# DESIGN REVIEW BOARD

DRB2014-27

Design Review of changes to the site plan related to the fuel station

# EAST GREAT FALLS RETAIL FUEL STATION 5300 10TH AVENUE SOUTH

# EXHIBIT J - LANDSCAPING PLAN

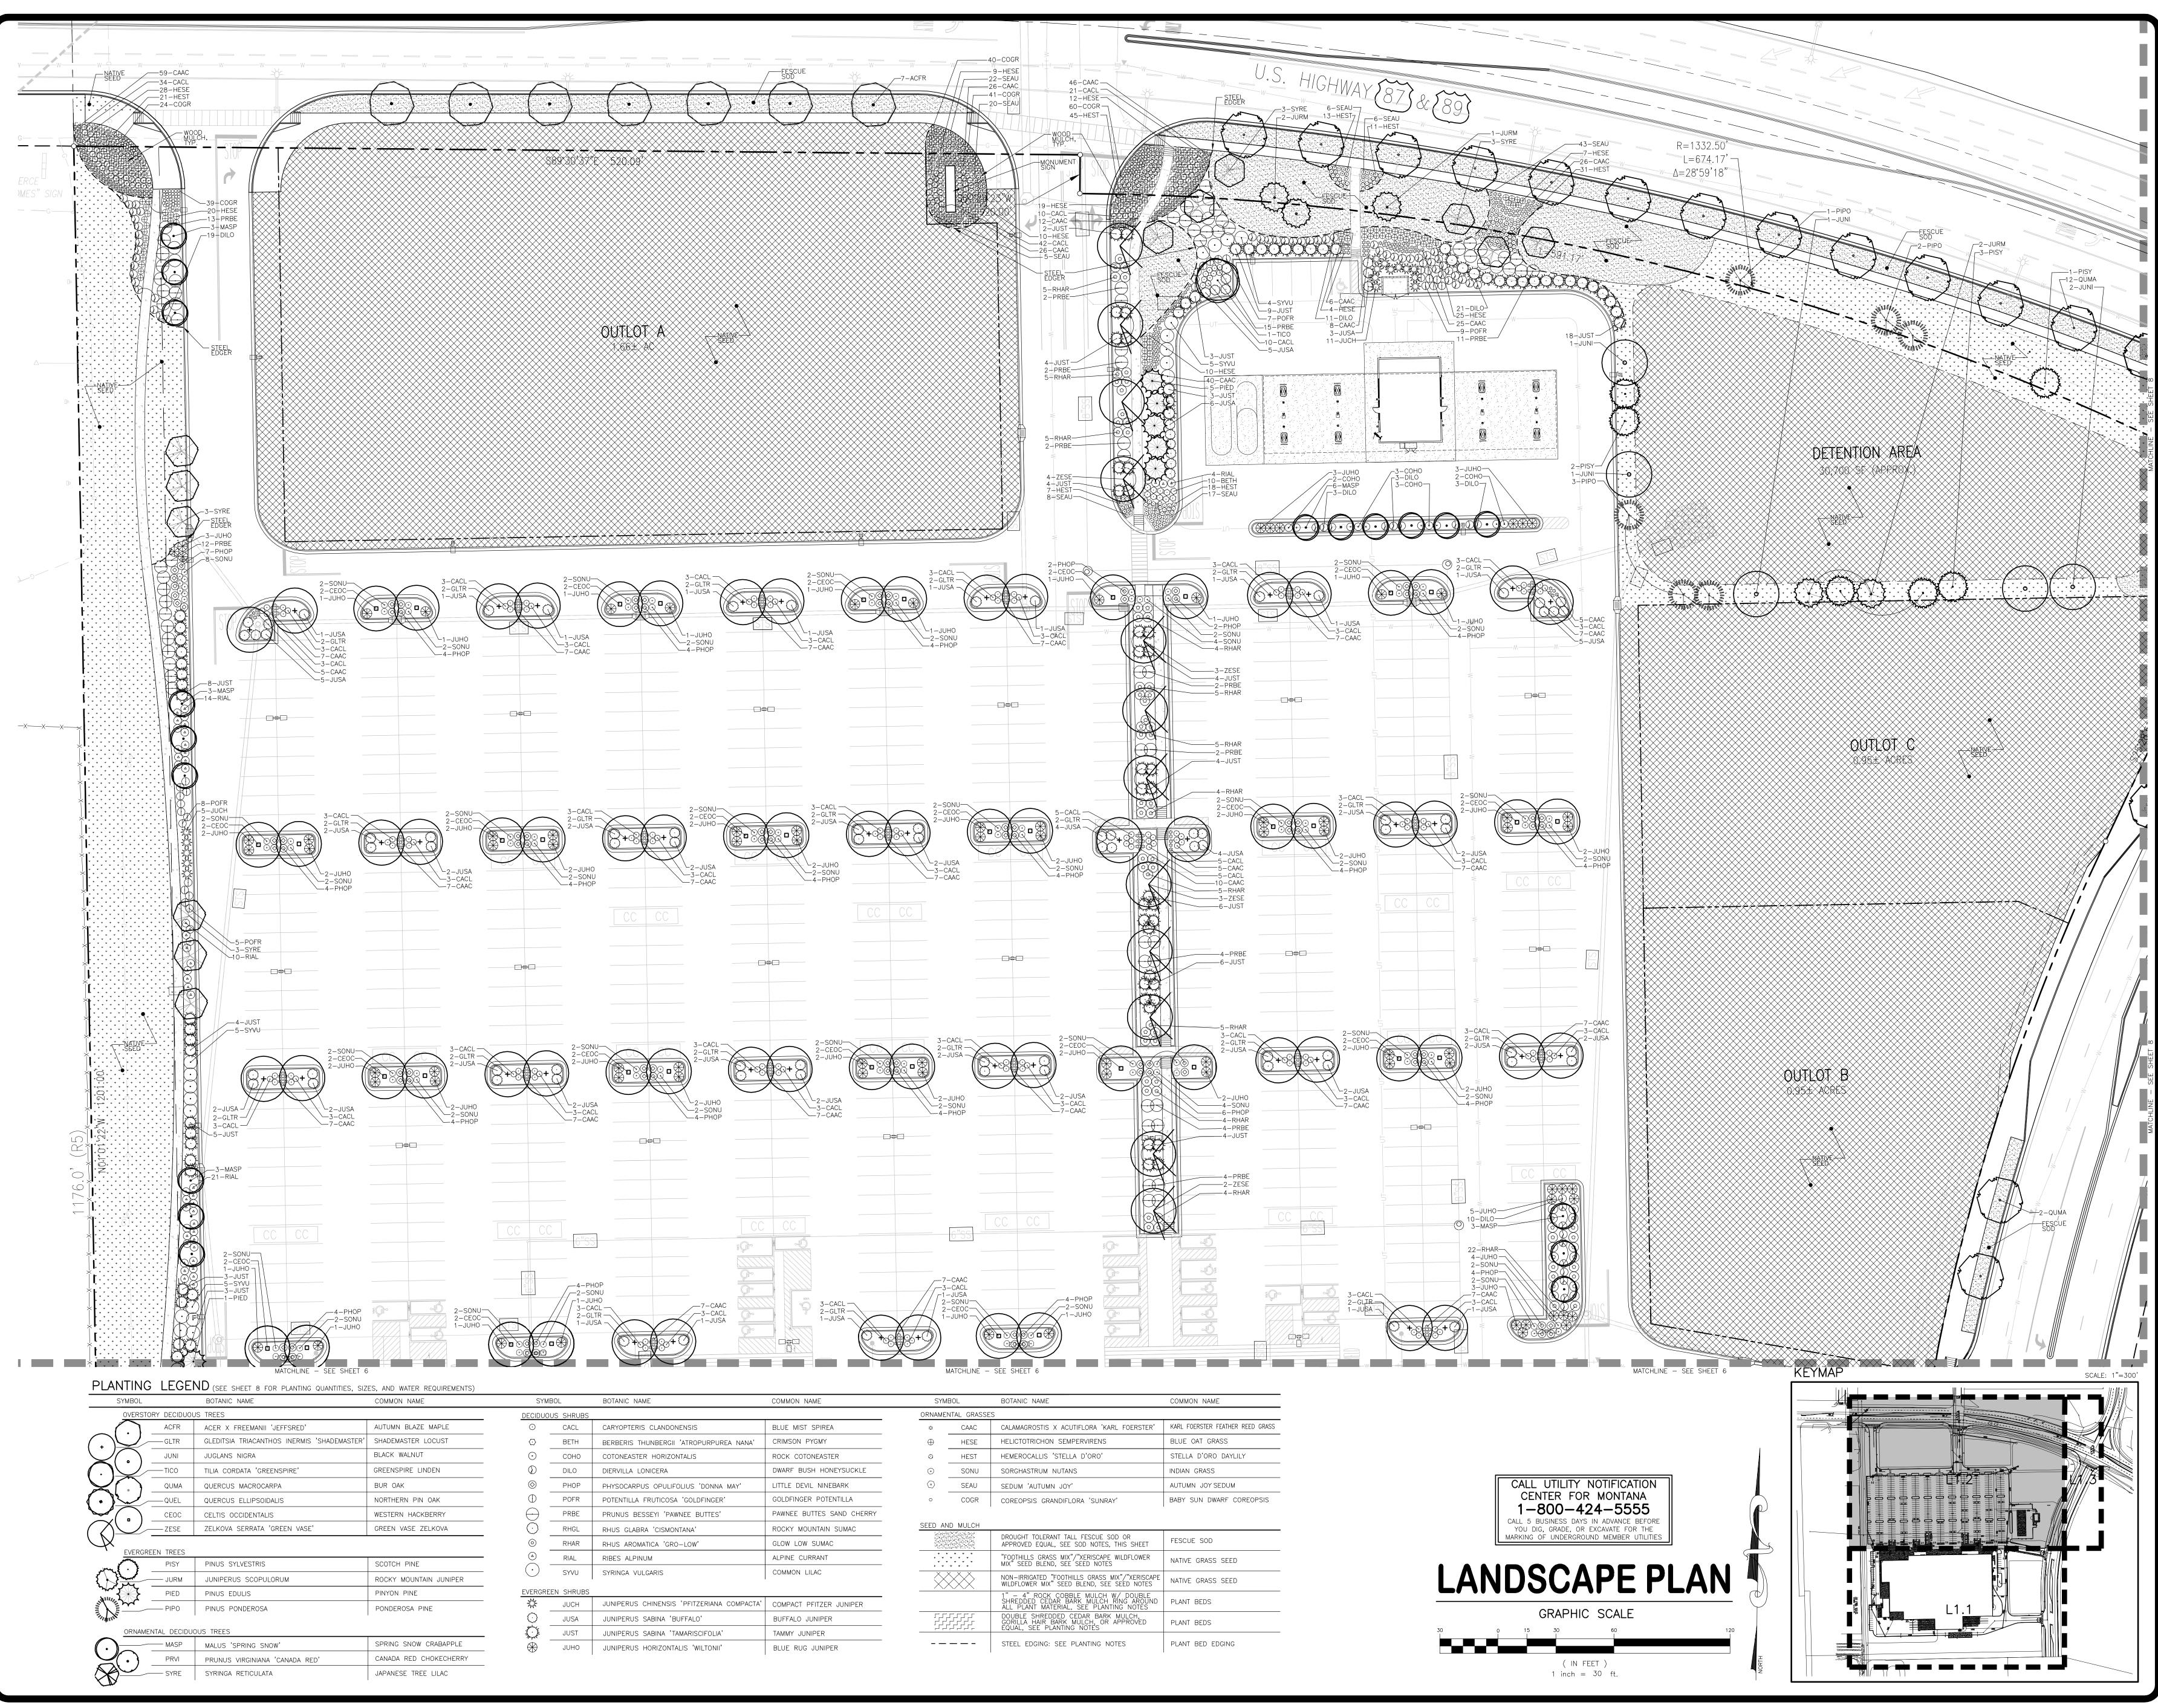
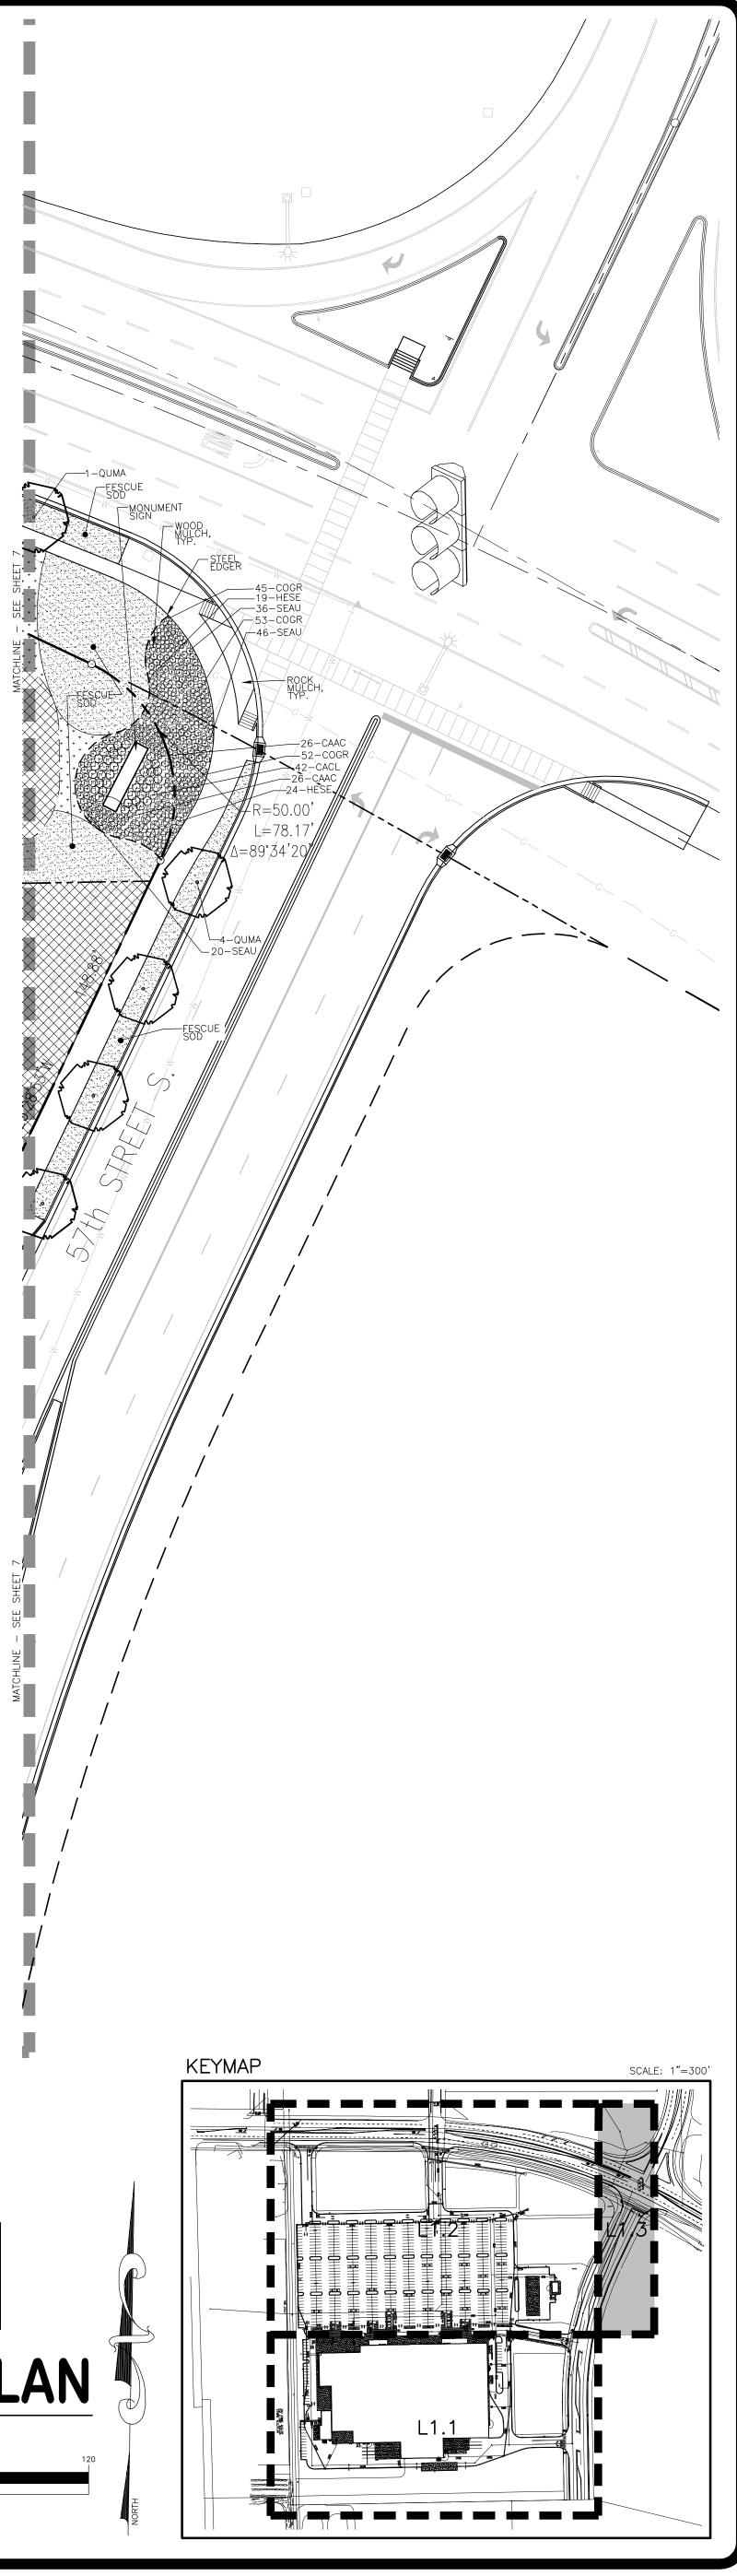
The applicant requested consideration of the use of xeric materials throughout the entire site. Staff concurs with incorporating xeriscaping as water conservation and eco-friendly design is especially pertinent on a parcel this size; however, in the area along the north of the detention pond and in the boulevard along Outlot A, staff recommends a traditional green boulevard style sidewalk to provide for a pleasant environment for pedestrians. In addition, the outparcels will be seeded with native grasses until developed, and the applicant will ensure that this seeding is established in order to prevent erosion and/or anything visually unappealing that may result from unkempt barren lots. The full landscaping plan is included as Exhibit J.

- Install boulevard turf grass in the area along the north of the detention pond and in the boulevard along Outlot A:
